Plant: Turkey Point Unit 3

Performance Indicator: IE01, Unplanned Scrams per 7000 Critical Hours

Question Section

Response Section

Figure-1

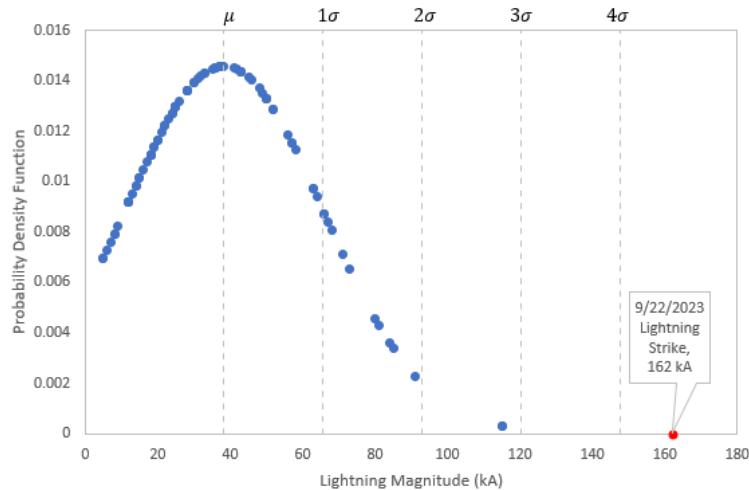
Figure-1 is based on a data set of lightning strikes occurring within a half mile radius of the Turkey Point switchyard over the last ten years. As is shown, this lightning strike was greater than four standard deviations (99.85 percentile) above the mean making this lightning strike an extreme statistical outlier.

The direct cause of the scram was the unprecedented magnitude of the lightning strike which created an induced voltage through the switchyard ground grid that arced across the string bus differential relay contact, resulting in a generator lockout. As the lightning strike itself was an extreme statistical outlier, this scram was caused by unique circumstances beyond FPL's ability to foresee or control and there is sufficient basis to warrant exception to the guidance as written in accordance with NEI 99-02, Revision 7, Appendix D, Page D-1.

During the September 22, 2023, Turkey Point Unit 3 scram, from 100% power; a lightning strike which resulted in a generator lock out. The reactor protection system automatically actuated, and the unit tripped. The NRC staff acknowledges the licensee's assertion that the magnitude of the lightning strike was more significant than what has historically been experienced in the area, however, due to the scram being unintentional and not part of a planned evolution or test, this scram would be considered unplanned under NEI 99-02, Revision 7. The NEI 99-02, Revision 7, list of examples that would not count as an unplanned scram are all related to planned evolutions that would result in a scram.
